Technical Newsletter

CHANGING A POM INTO A STAINLESS STEEL AGITATOR

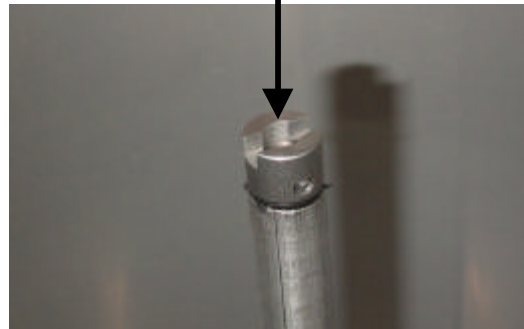
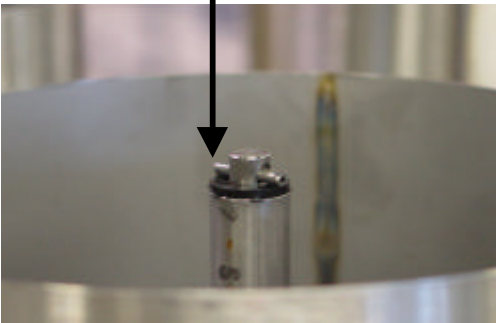
Problem: Changing a POM agitator into a steel agitator (3 ltr or 6 ltr.)
Only possible with stainless-steel canisters.

How: Take PIN,SPINROL (drawing 2751 part 17) out of agitation shaft
Place BUSH,CENTER (drawing 2751 part 9).
Place PIN,SPINROL back into the agitation shaft
Place POM agitator 3 Ltr or 6 Ltr. (drawing 2751 partno.1803439-SP or 1803441-SP)

For changing from stainless steel to POM use instruction in reversed order.
